YG-DCO-126

Yorkshire Green Energy Enablement (GREEN) Project

**Document 8.24 Applicant's Comments on Interested Parties' Deadline
4 Submissions**

**Final Issue A
July 2023**

Plan View 4
Low Loaders passing
Scale 1:200

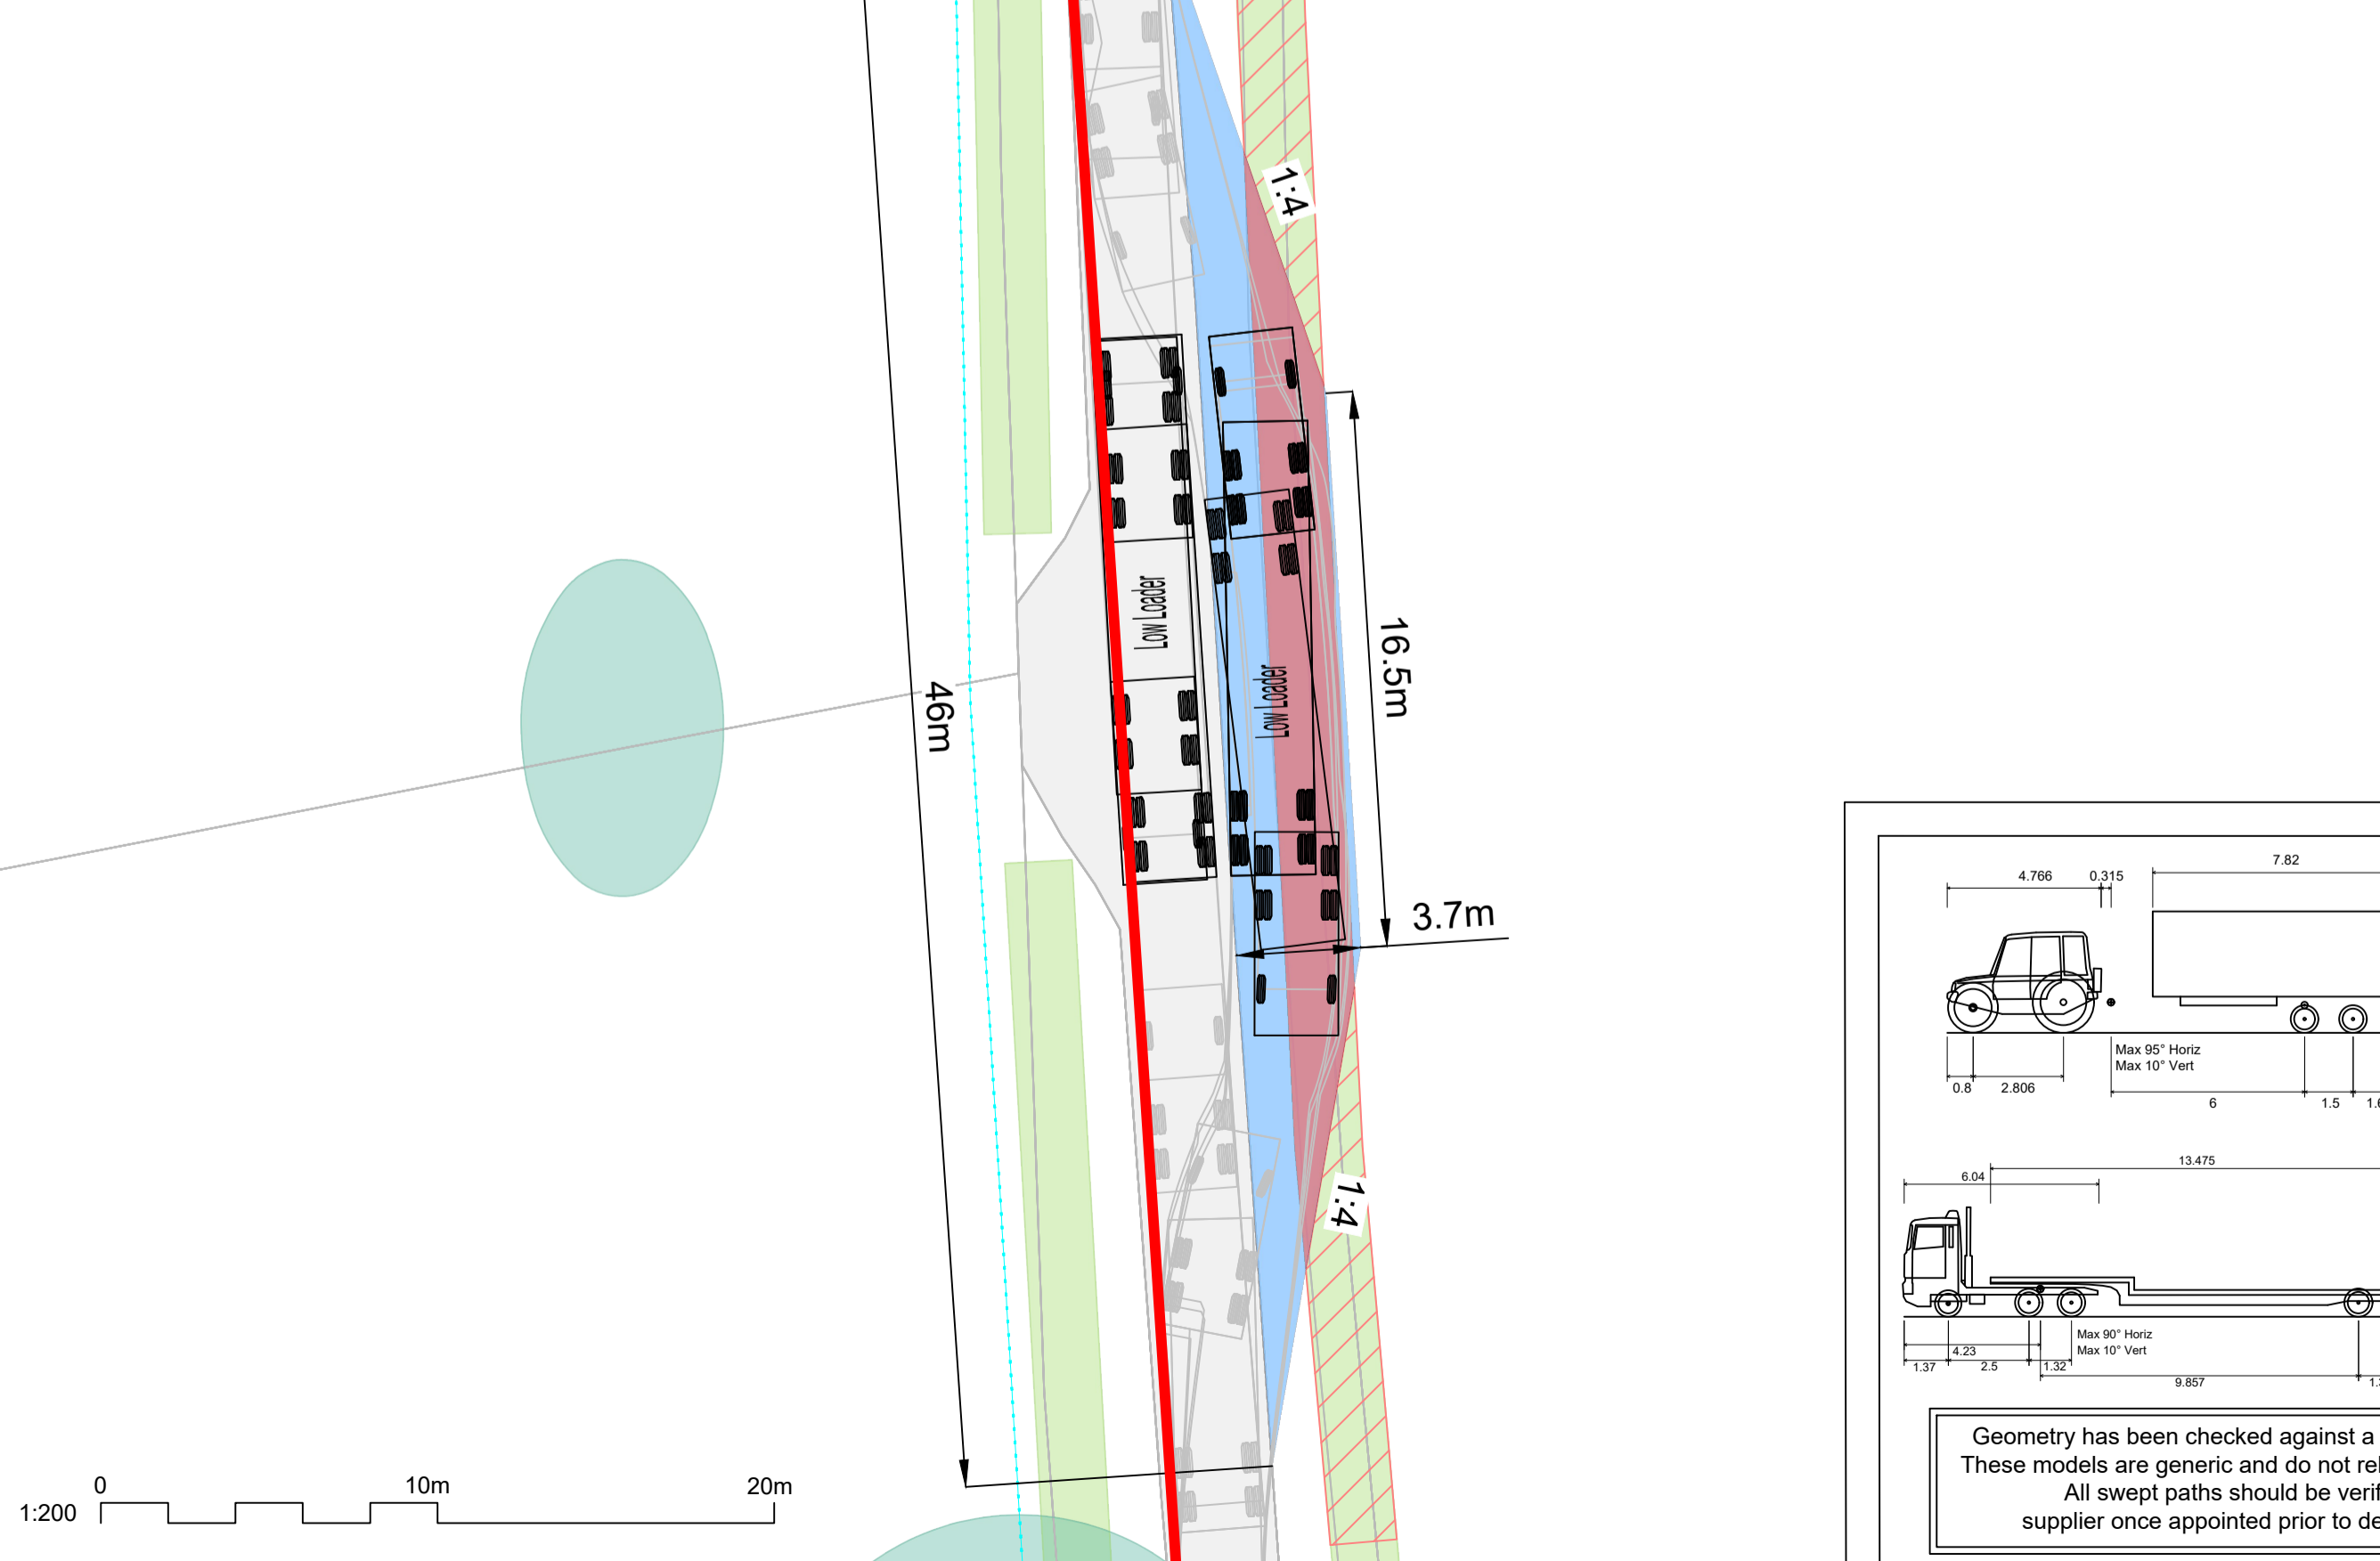
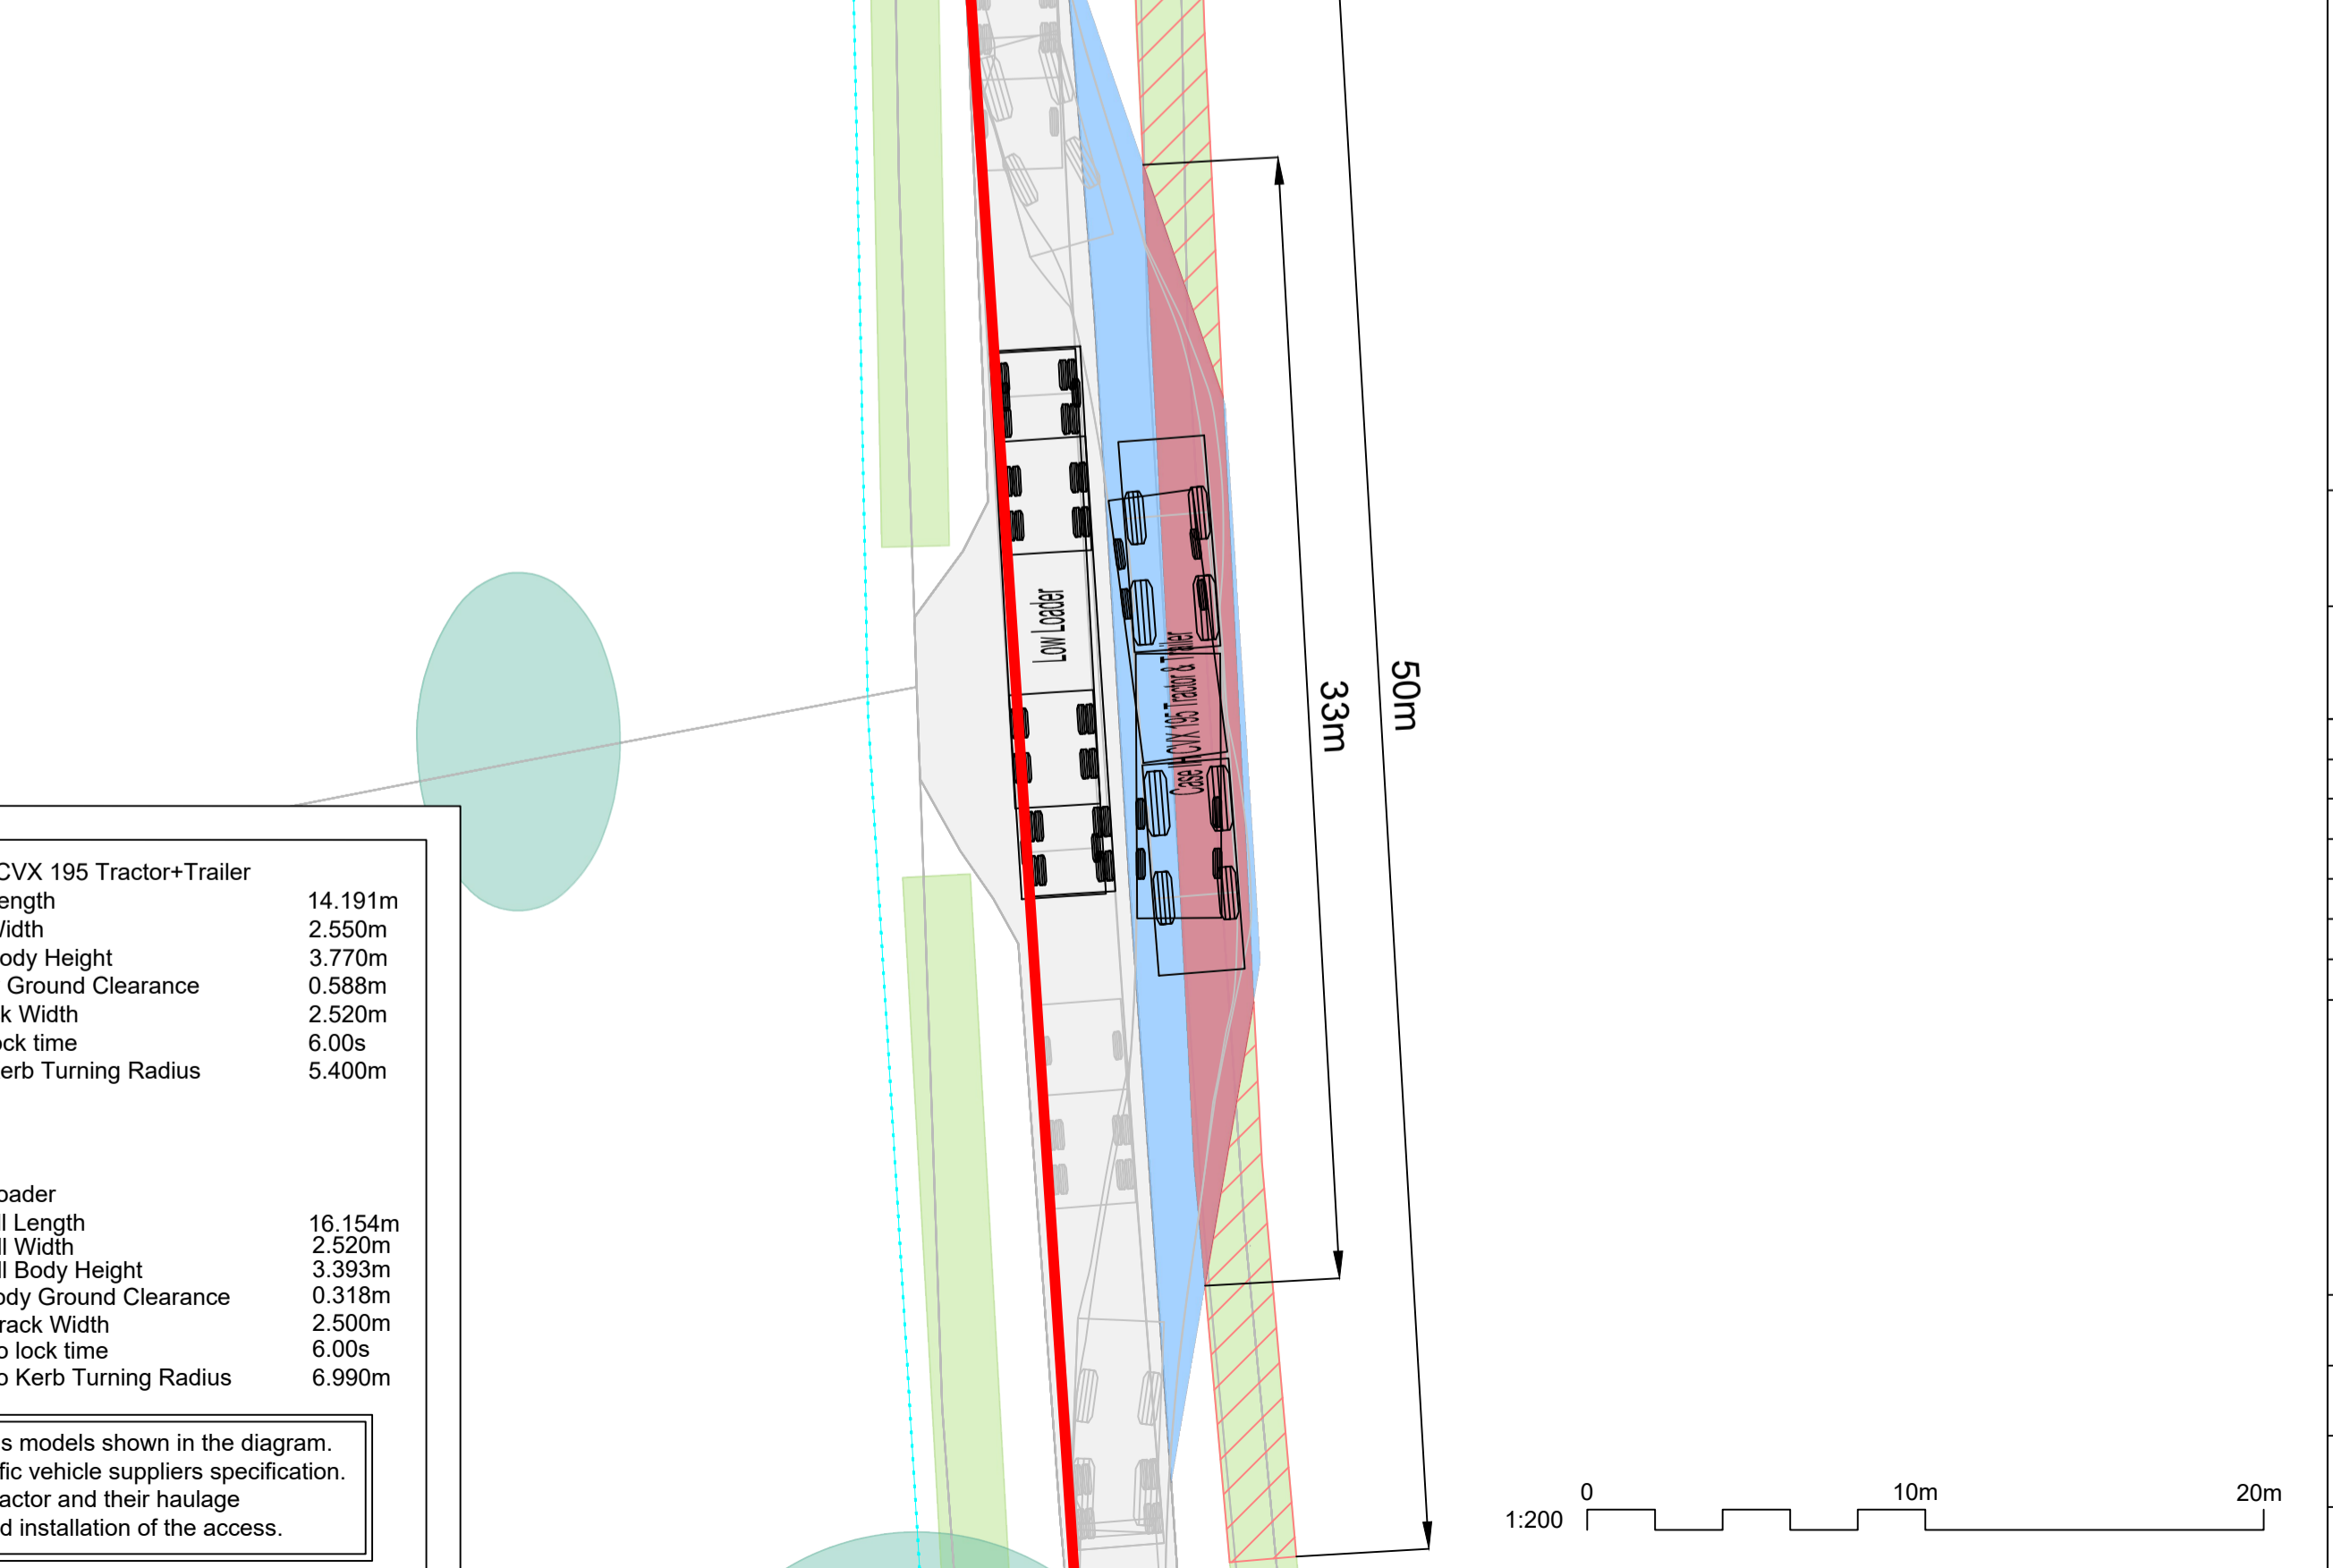
Reference	Topic	Applicant's Response
Action Point 22	Request for a meeting	National Grid met with Mr Stephenson and his clients on Friday 16 June 2023.
Action Point 30	Construction traffic and proposed alternative access.	a) National Grid note the deliveries required for the farming operations, and National Grid will manage the construction traffic to seek to minimise the impact on deliveries during the construction phase. This will be undertaken by the installation of passing places along the public

Reference	Topic	Applicant's Response
		<p>highway, which provide additional passing places to those provided in the bellmouths to be installed, as well as coordination with the Agricultural Liaison Officer (ALO), as set out in the Code of Construction Practice (Document 5.3.3B(C)) and the Traffic Coordination Officer (TCO) as set out in the Construction Traffic Management Plan (Document 5.3.3F (B)) submitted at Deadline 5. To aid understanding National Grid have submitted an illustration of what the road could look like with passing places shown (this is for illustration purposes only, and may vary a during detailed design), in Appendix A of this document.</p> <p>b) 25,525 vehicle movements (two way) shown in Appendix 12A Traffic Modelling Tables (Document 5.3.12A [APP-148]) are indicated for Access Points (AP) 95, 96, 97, 98 and 99. 12,858 of these movements will be to access point 95, which is on the junction of Corban Lane, with HGV movements coming from the east on Corban Lane turning right into this bellmouth, therefore will not be travelling further up Newlands Lane.</p> <ul style="list-style-type: none"> i. National Grid are not proposing to double the size of the road for the construction period as it is not necessary, suitable passing places will be included along the lane during the construction period. ii. National Grid are proposing to construct passing places to allow construction and farm traffic to pass on the lane. National Grid are awaiting the submission of a sketch of what suitable passing places would look like from Mr. Stephenson's the land agents and his clients point of view but have produced the above referenced illustration as this information has not yet been provided. iii. National Grid are not proposing a connecting road between the two construction compounds. The construction compounds are for use by separate contractors (overhead line contractor and CSEC contractor) and have separate access points, AP95 for the southern compound and AP98 for the northern compound.

Reference	Topic	Applicant's Response
		<p>Constructing a road between the two compounds would involve an additional stone access track and the removal of an additional amount of tress on the boundary between the two different land holdings which is not required. This change would also move the access onto another party's land. National Grid do not believe this isrequired, with traffic being managed along the lane, and passing places, and bellmouths being installed.</p>
